722-724 CONGRESS STREET

APPLICATION FOR PERMIT

To change use from service station to office bldg with alterations as per plan

724
742 Congress St.

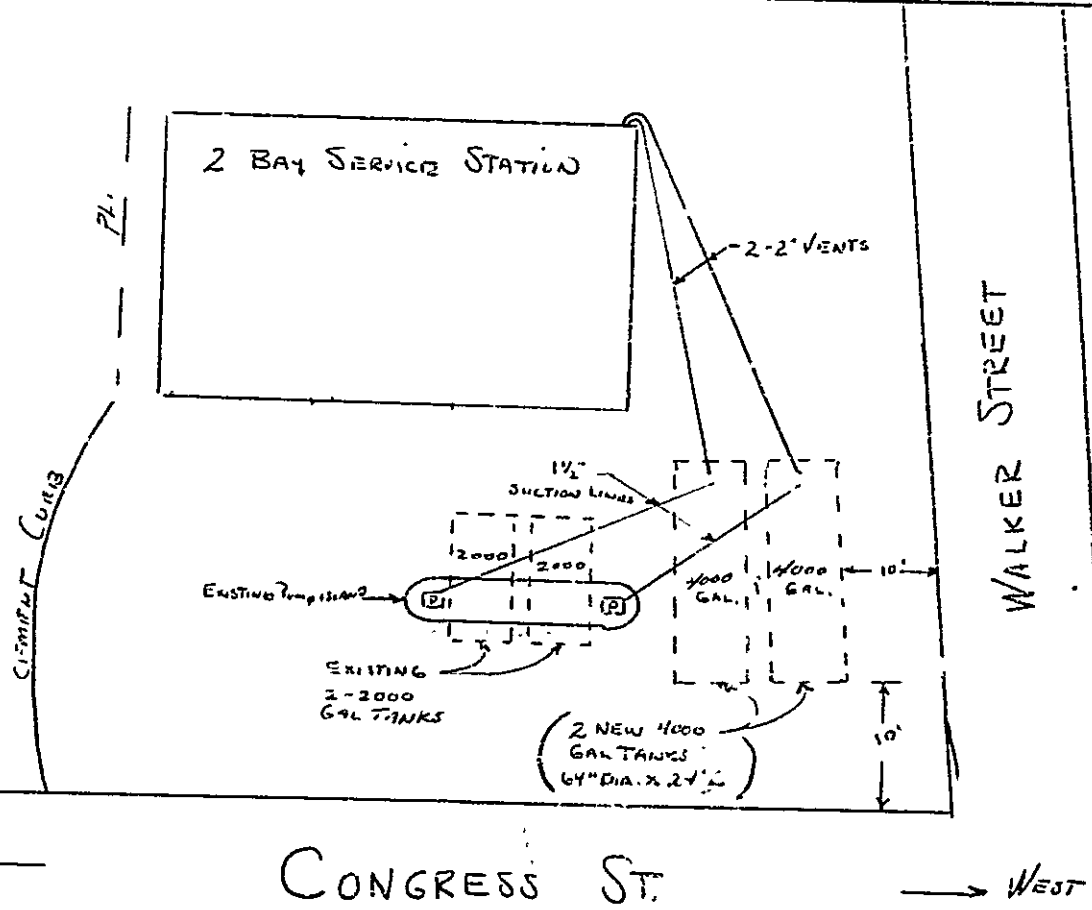
Before tank and piping are covered from view, installer is required to notify the Fire Dept. Headquarters of readiness for inspection and to refrain from covering up until approved by the Fire Dept. Headquarters.

These tanks of 3000 gallons capacity are required to be of steel or wrought iron no less in thickness than # 7 gauge; and before installation are required to be protected against corrosion, even though galvanized, by two coats of tar, asphaltum, or other suitable rust-resisting paint, and special protection wherein corrosive soil such as cinders or the like.

Pipe lines connected to underground tanks, other than tubing and except fill lines and test wells, must be provided with double swing joints arranged to permit the tank to settle without impairing the efficiency of the pipe connections.

Owner and installer will have to bear the responsibility for the structural capacity of the tank to support loads from above such as heavy motor trucks.

If tank will be so located as to be subjected to the action of tide water or "ground" water, adequate anchorage or weighting must be provided to prevent "floating" when tank is empty or nearly so.
